What We Heard Report: Active Transportation Improvements: Corridors

August 2022

Active Transportation Improvements: Corridors

Design Option A – Shared pathway on east side of Fort Road

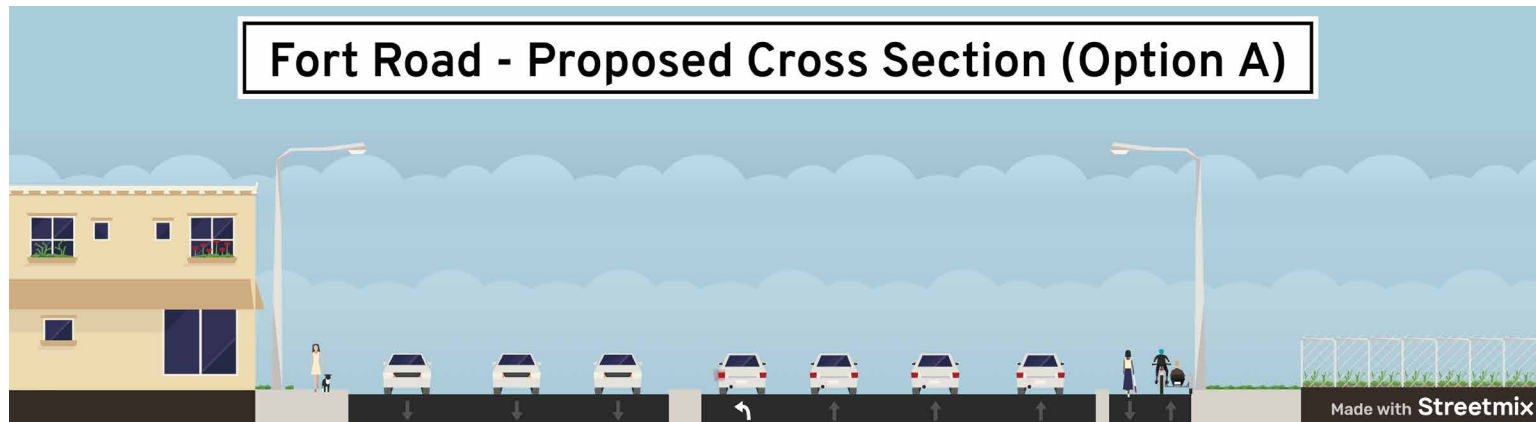
Respondents note what they like most about Option A is its proximity to public transit—the Clareview and Belvedere LRT stations and bus stops. Respondents also note that they like that the bike lane is separated/protected from the vehicle lanes to enhance safety for all users. Respondents also like that this connection will provide links to existing bike infrastructure.

Respondents suggest that reducing the number of vehicle travel lanes would benefit this option by providing additional space which could be allocated to enhance the active transportation connection and improve safety for all users. A seven vehicle lane road is believed to be too wide for safe crossings.

A clear and substantial separation between the vehicle traffic and shared pathway is desired. It is suggested a green boulevard would suit this purpose and trees could be added to enhance the comfort and experience of users. Many suggest that a shared pathway should be provided on both sides of the corridor.

There is a concern about access across the shared pathway to the businesses on the east side of the corridor. The City is encouraged to ensure safe crossings and to continue to expand the active transportation network by adding connections from this pathway to others within the area, as well as key destinations.

Design Option B – Shared pathway on west side of Fort Road

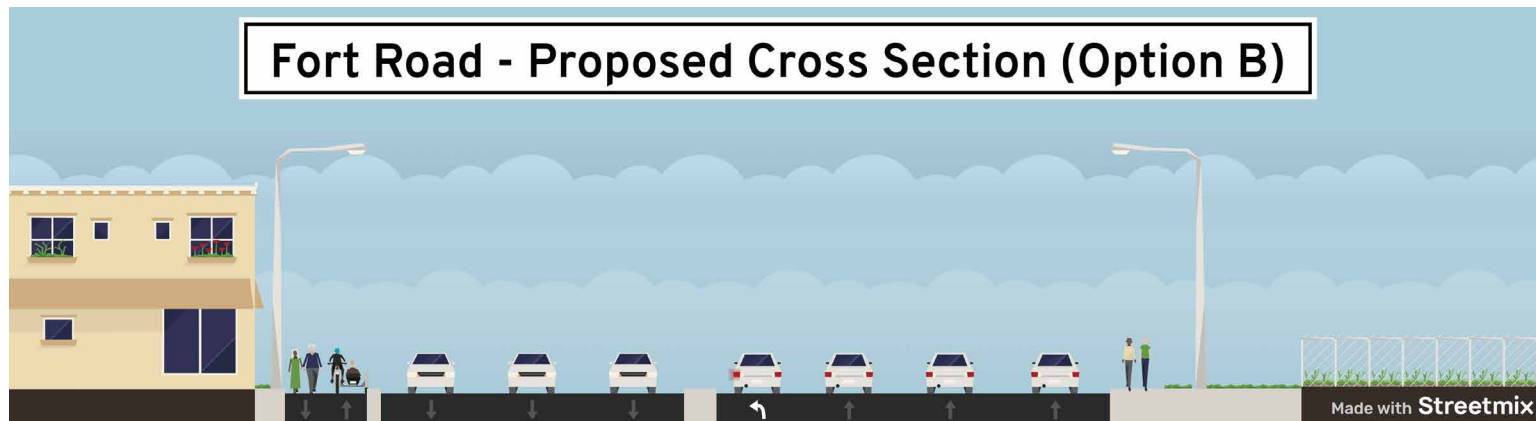
Respondents note what they like about Option B is its proximity to both the residential neighborhoods and area businesses. It is felt that this will enhance safety, and encourage pathway usage, by minimizing the need to cross Fort Road. The separation of bikes and cars is also noted. Many respondents however, do not support this option and indicated a preference for Option A.

Similar to Option A, there is a desire to reduce the number of vehicle travel lanes and devote the space to the active transportation connection. Many respondents suggest that shared pathways be placed on both sides of the corridor. To enhance safety, other suggestions include increasing the separation between the vehicle lanes and the shared pathway, widening the sidewalk, and creating a separation between bikes and pedestrians on the pathway.

Proposed Design – Shared pathway on west side

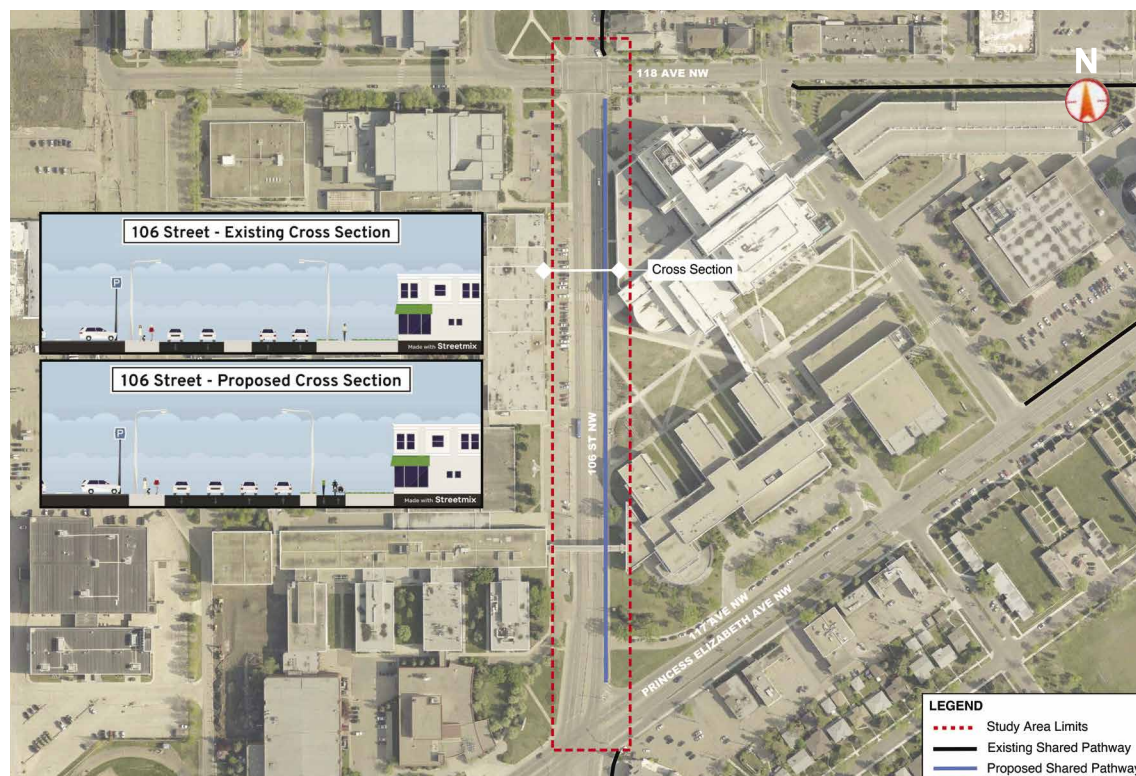
What respondents noted most often about what they like about the 127 Street option is the connection it provides to the existing active transportation network, filling the gap and expanding the network overall, providing additional transportation options to Edmontonians. The narrowing of the vehicle travel lanes was also noted as something that is liked about this option, which respondents believe will provide the benefit of reducing speed. Enhancing safety for users is also noted.

Suggested improvements to the 127 Street option include physically separating the bike lane from the roadway (by adding a barrier or green space, for example). Respondents feel that removing a car lane would provide space to assist with this separation, as well as better balance the allocated space for distinct users and improve safety overall. Crossing safety is a primary concern with suggestions to provide bikes with clear right-of-way/unimpeded crossings and to ensure safe crossings for those who bike and walk across Yellowhead Trail. Trees were noted as a priority with a desire to retain the trees wherever possible. Some commented that a separation between bikes and pedestrians along the pathway would be beneficial for safety.

Proposed Design – Shared pathway on east side

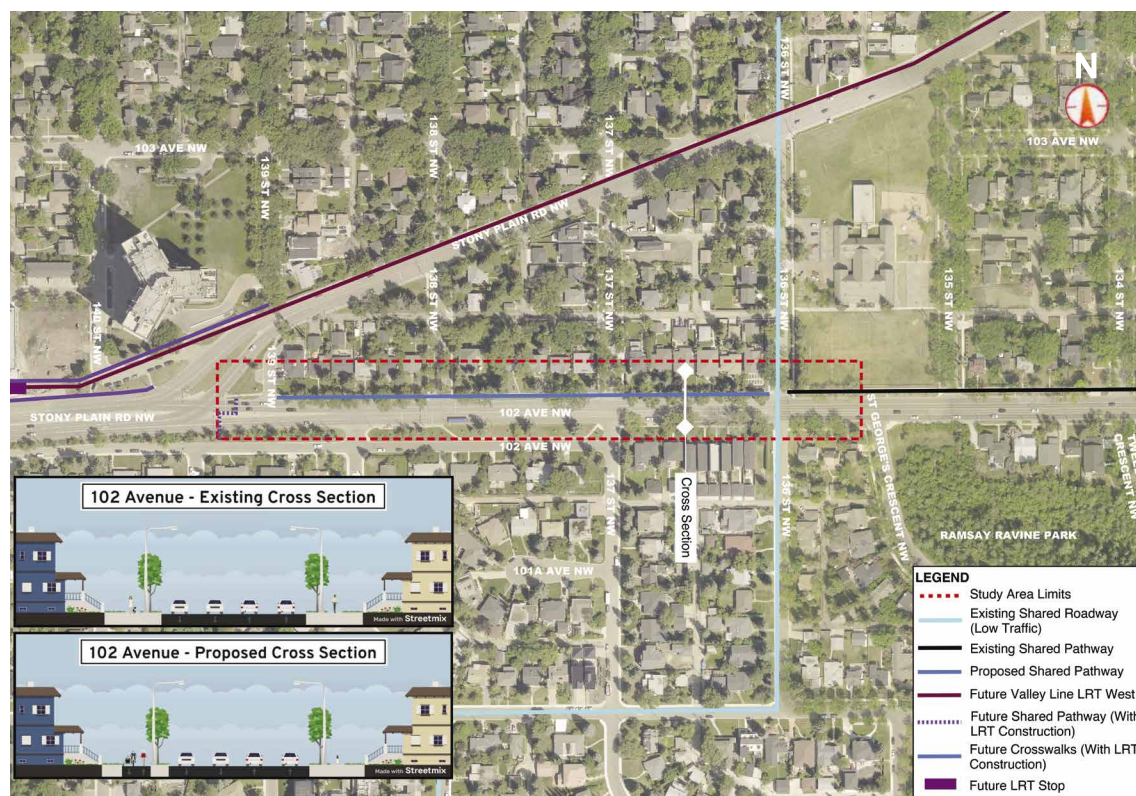
What respondents like most about the 106 Street design is that it continues to expand the active transportation network and fills existing gaps. Both the separation from traffic and width of the path are also noted as what respondents like, with some adding that these features increase safety. Respondents also like the access that the path provides to NAIT, as well as the removal of the centre median.

Respondents suggest improvements to the 106 Street design including a separation of bikes and pedestrians along the shared pathway, noting the heavy foot traffic on campus and the potential for conflicts when both bikes and pedestrians will share the same space. Widening the pathway overall is also suggested as a solution.

Some suggest that reducing the number of vehicle lanes will help improve the design overall, adding space to the active transportation connection. The addition of trees is desired, as well as a focus on safe crossings and a physical separation of the active transportation lane from vehicular traffic.

Proposed Design: Shared pathway along north side of 102 Avenue

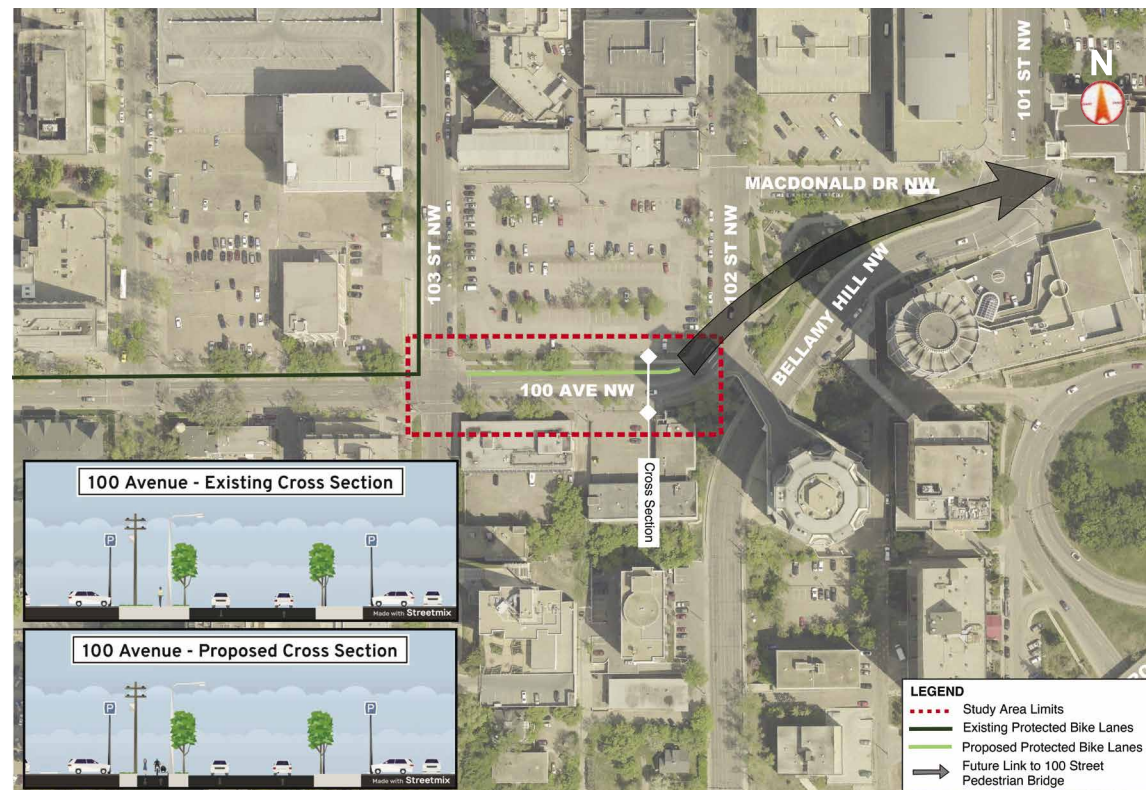
Most respondents note that the expansion of the existing network and the added connection created by this design are what they like most about the 102 Avenue option. A few respondents noted they like that the bike lane is protected and that the design enhances safety.

Crossings were mentioned most often as what respondents suggest would improve the 102 Avenue design. Respondents note a desire to maintain trees along the corridor. Safe and efficient crossings are desired, with specific locations identified as Stony Plain Road at 102 Street and at the future LRT station. A preference for raised crossings is also mentioned. Respondents are eager for the network to expand further, noting that this connection should extend further to the west, as well as both north and south of this location. A few respondents suggest that bikes and pedestrians should be separated on the pathway, with a few others suggesting that a protected bike lane is preferred over the shared pathway.
